USBANCORP TOWER & PLAZA

Exterior Alterations

Design Review

September 19, 2013

SOUTH PLAZA - PROPOSED

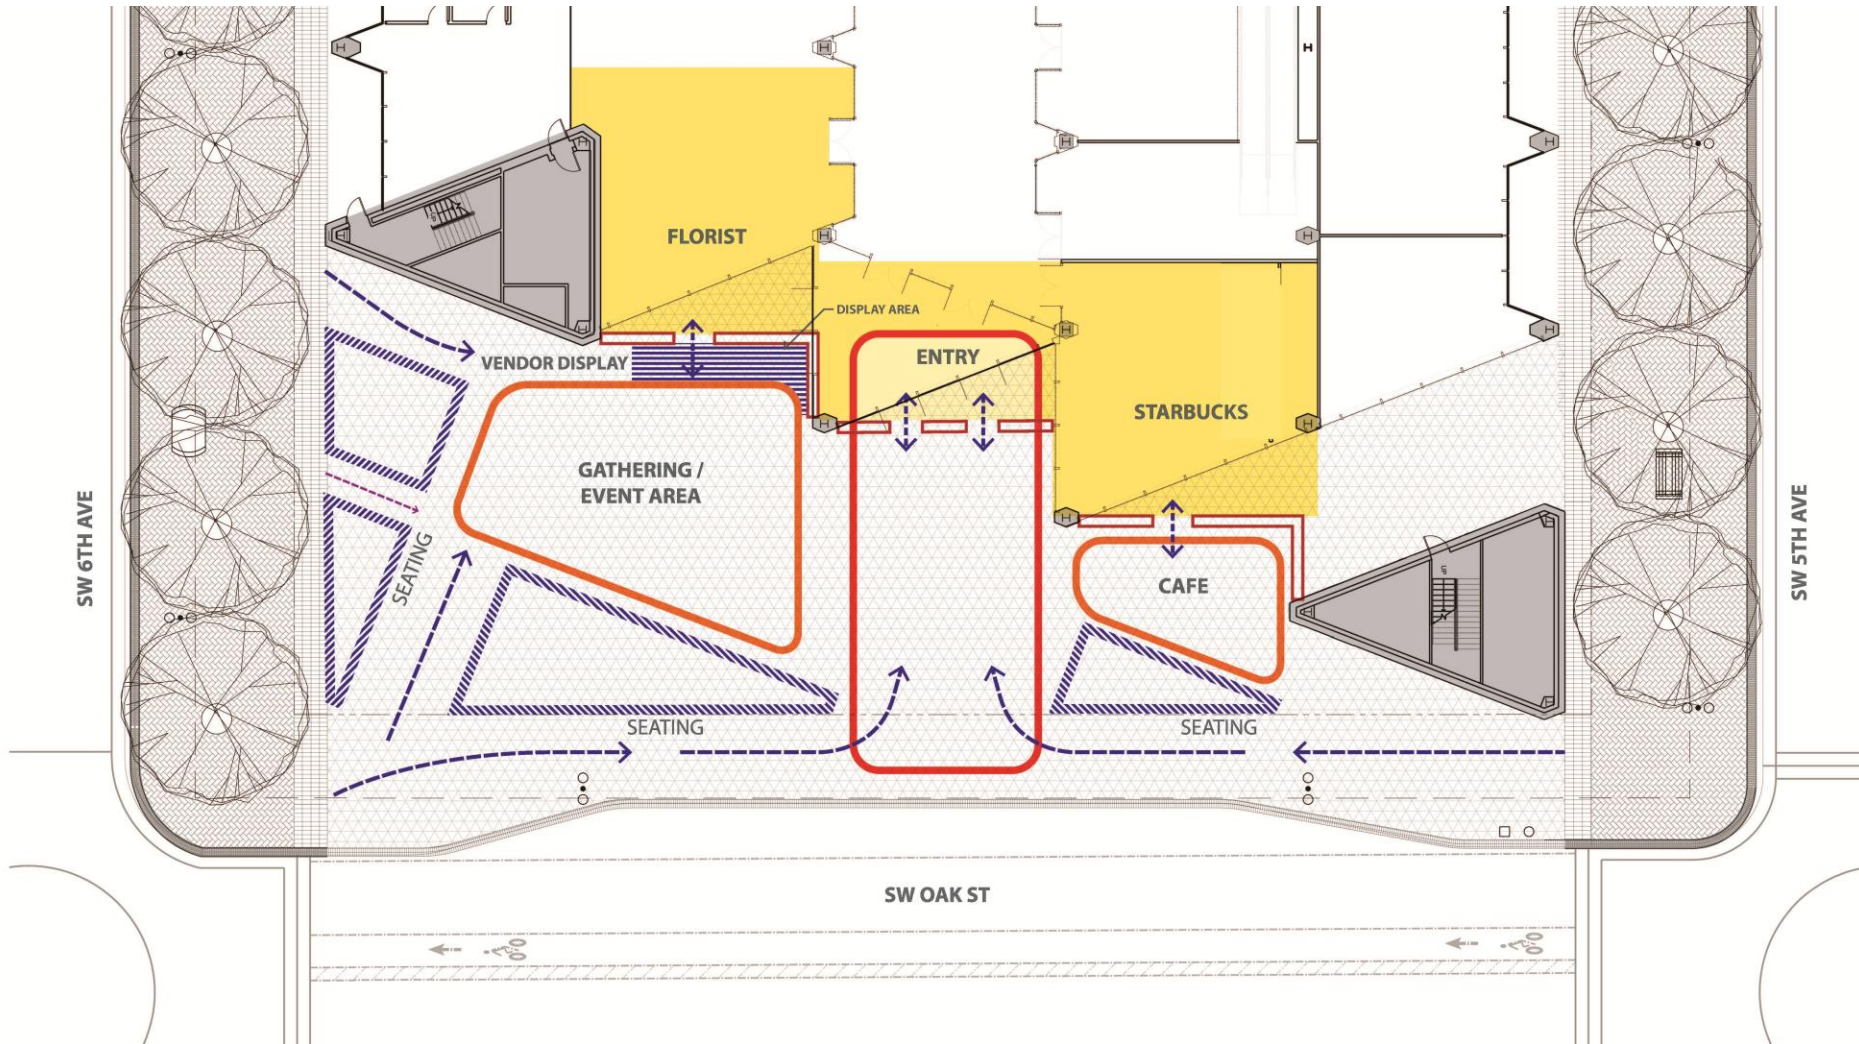
1. Reduce number of materials - metal finishes
2. Plaza – Seat wall depth, Trees, Street side Planter edge
3. Existing building granite walls
3. Weather Protection at Entrances
4. Roof Deck
5. Vestibule

Proposed Design successfully addresses all of the comments from the last hearing:

- ✓ 1. Reduce number of materials - metal finishes
- ✓ 2. Plaza – Seat wall depth, Trees, Street side Planter edge
- ✓ 3. Maintain integrity of existing building granite walls
- ✓ 4. Weather Protection at Entrances
- ✓ 3. Roof Deck
- ✓ 4. Vestibule
